NUMBER: 08-100-14

Loss Of Power Heated Mirror Function - Recall P61 Interim Repair

2011 - 2013 (JK) Jeep Wrangler

Fig. 1 Totally Integrated Power Module

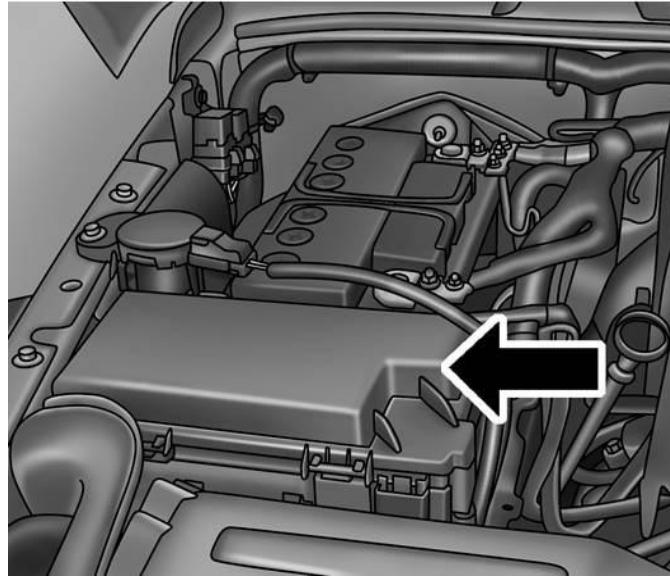
The power side view mirrors may experience a loss of right and/or left heated power mirror function. Water may travel along the heated power mirror wiring harness and into the heated power mirror electrical connector(s). This can cause corrosion inside the heated mirror connector(s) and the formation of a resistive bridge between the power and ground electrical terminals. A resistive bridge between the power and ground electrical terminals in the heated power mirror connector(s) could cause an electrical fire without warning.

In the meantime, if the customer is uncomfortable with the current situation, remove the 10 amp red M35 heated mirrors fuse from the totally integrated power module ([Fig. 1](#)).
